DWG. TITLE		SHEET 1/5		REV.
☒ BASE ES7632BT-0614-168ZZ		☐ BASE ES7632XC-1114-168ZZ		1A
				SIZE A3

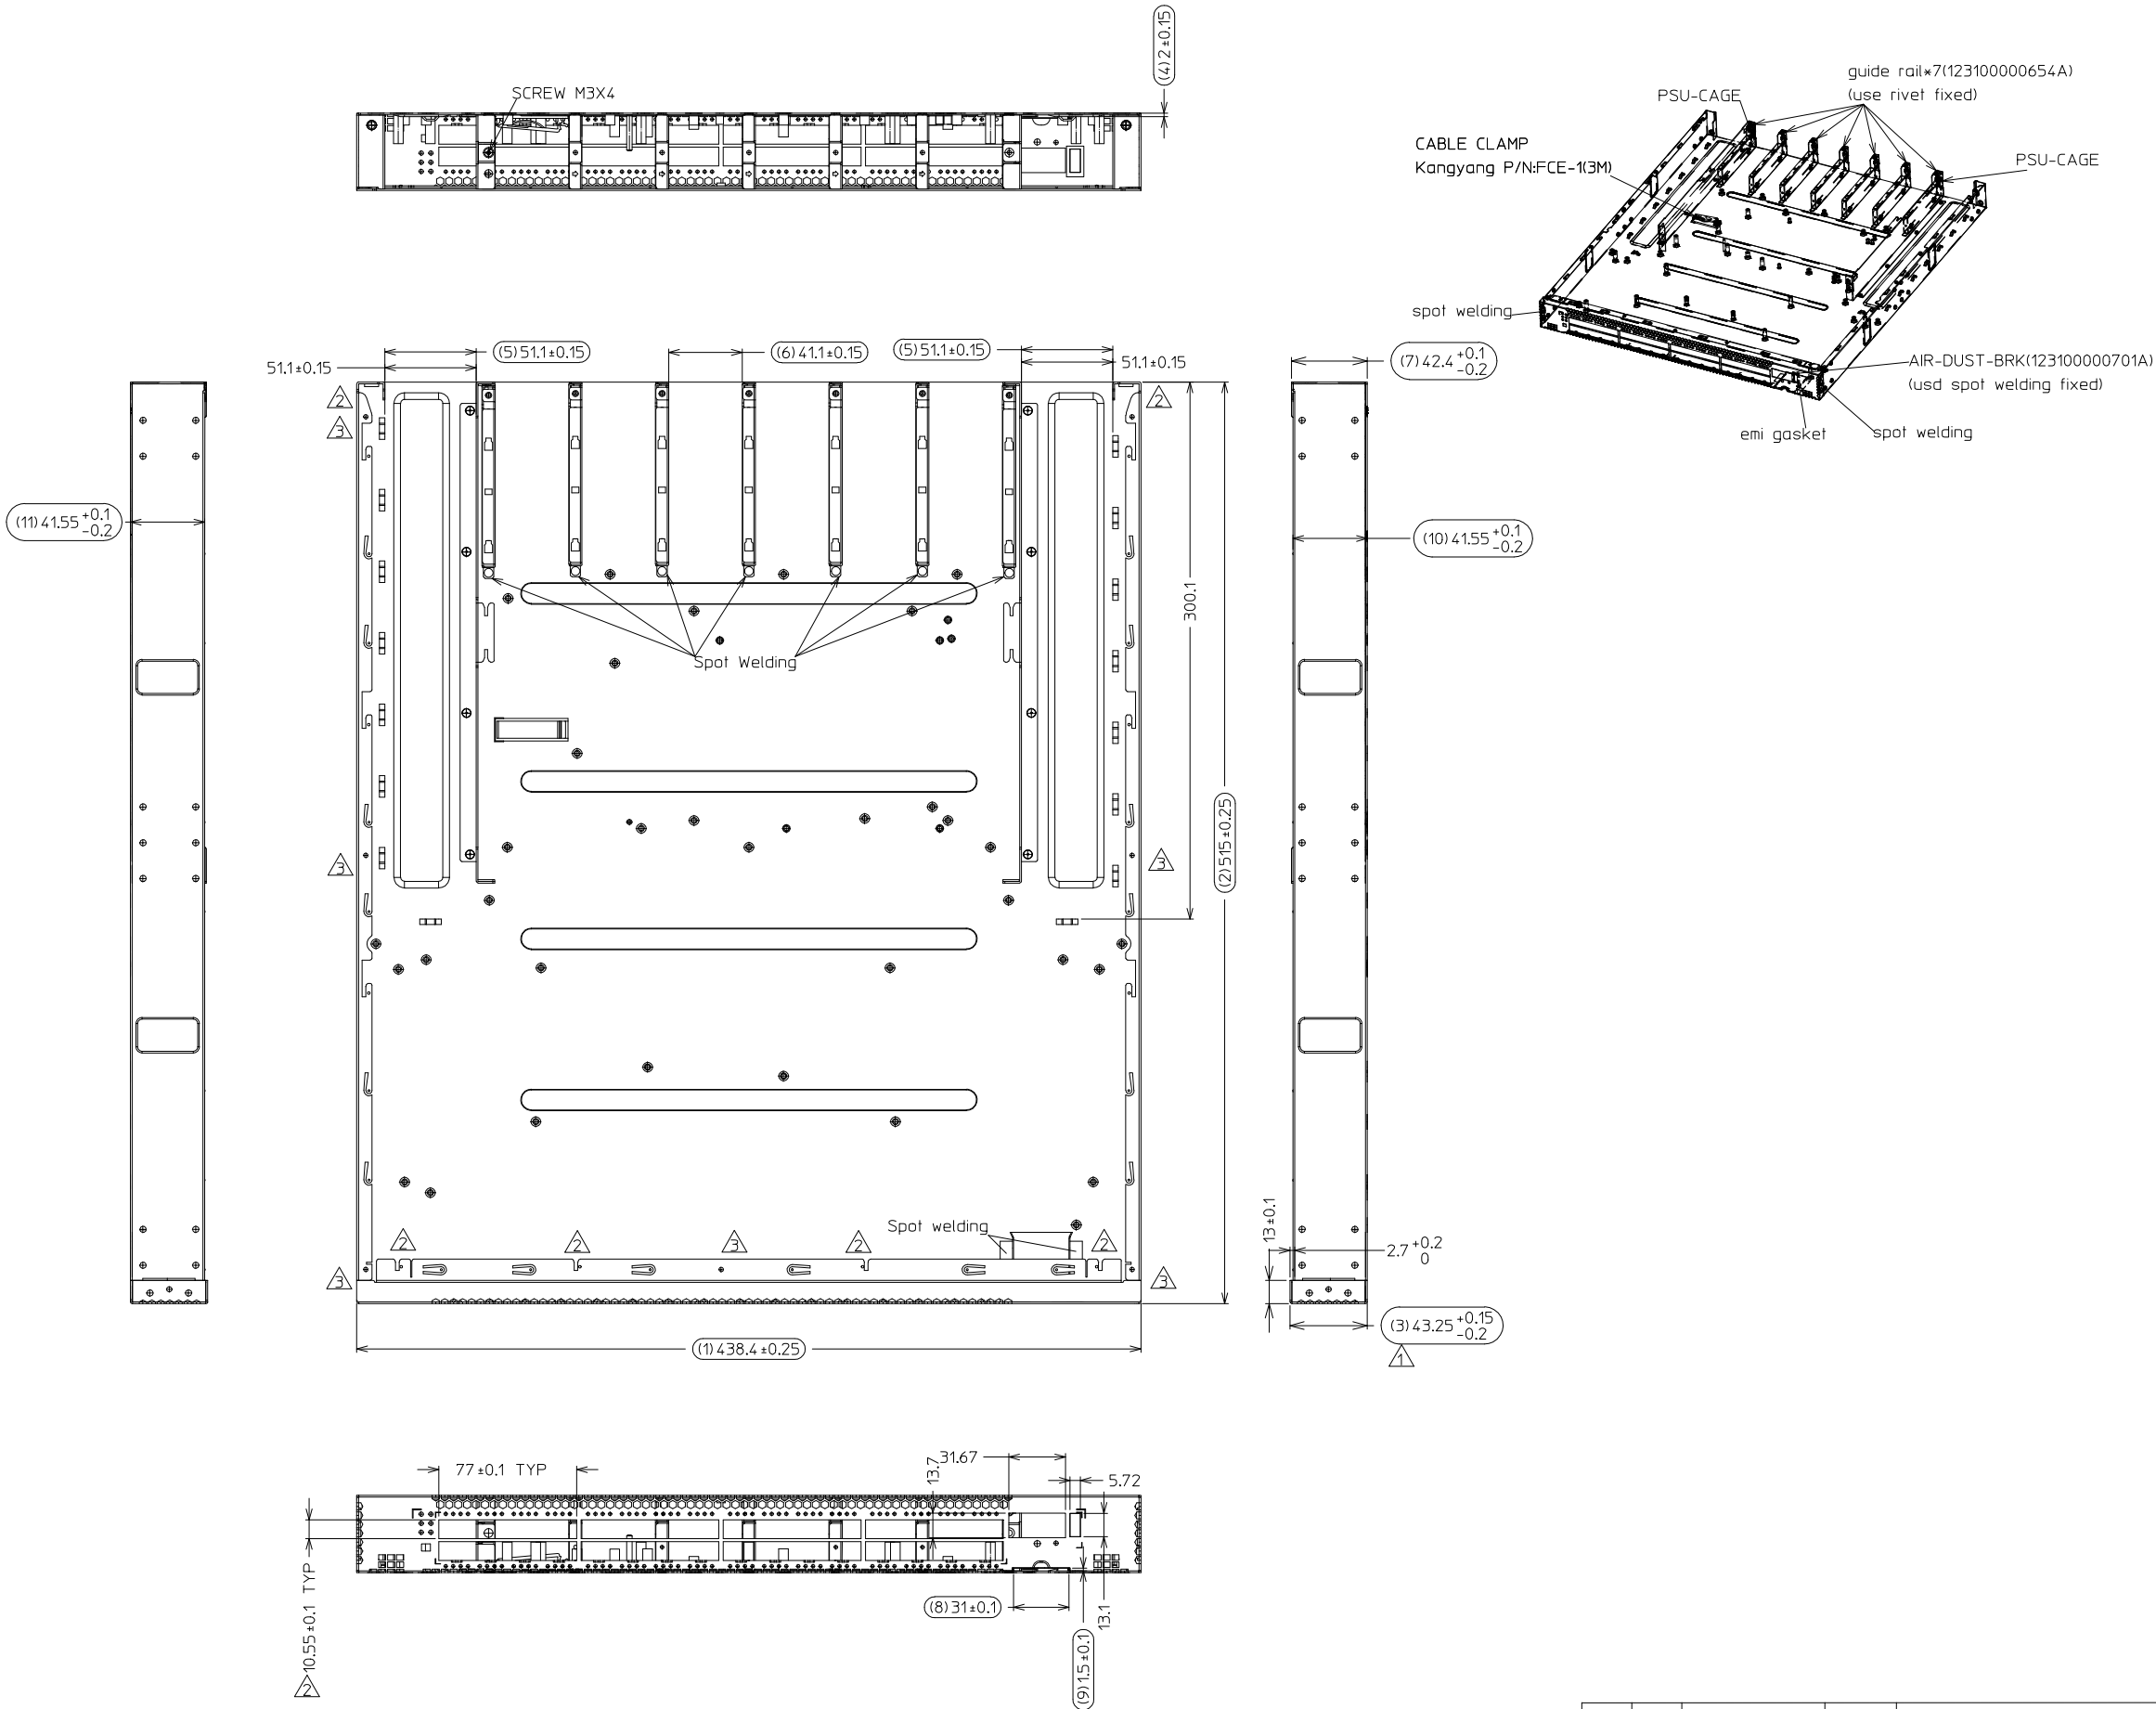
Reason			UNSPECIFIED TOL'S (± 0.2 mm)												FINISH.			
This document and the technical data disclosed are proprietary to Accton Tech. Corp. and shall not be duplicated, used, released, or disclosed without expressed written permission.		change emi-gasket thickness (1.0 to 1.5 mm , see p4) 8/14'15	ANGLE ± 1°	DIM.	GRADE	0	1	2	3	4	5		COATING:PANTONE 3C2X					
		add M3 screw for EMI 0519'15				0	16	0.05	0.1	0.15	0.2		0.2	0.5	PART NO. ☒ 123100000708A ☐ 123100000778A		SCALE 1:4	UNIT $\frac{MM}{(IN)}$
		add dot & cut material 4/20'15	ROUGHNESS	16	63	0.05	0.15	0.2	0.3	0.3	0.8		DESIGN	THF	0814'15			
				63	250	0.05	0.2	0.25	0.4	0.5	1.2							
		CHANGE HIGH 43.5 TO 43.25 3/4'15	ZONE	DESCRIPTION	250	500	0.1	0.25	0.3	0.6	0.8		1.8	MATERIAL SECC T=1.0MM				
					500	1000	0.3	0.5	0.8	1.2	3.0
